HIGH PRESSURE NEWS

1000bar radial piston pump

BRK1001 replaces BRK11

BRK1001

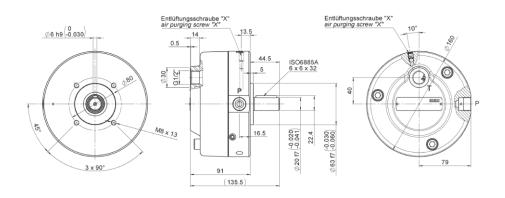
The **proven 1000bar** pump, type BRK11 has been further developed by our **engineers** to the new type **BRK1001**. The following table gives you a comparison of the features :

Feature	BRK1001 (new)	BRK11
Connection	Maximator	G-1/4"
Suction connection	G-1/2" 90°	G-1/2" 120° and 144°
Standard sealing	FKM	NBR
Bleeder screw	Yes*	No
Length (without shaft)	91 mm	83 mm
Outer diameter	160 mm	160 mm
Interface motor side	Identical	Identical
BIERI-Pumping elements	PEH	PEH
Bearings	Identical	Idendical
Selfventing and selfpriming	Yes	Yes

*With the tank on the top, it allows the pump to be completely filled befor start-up.
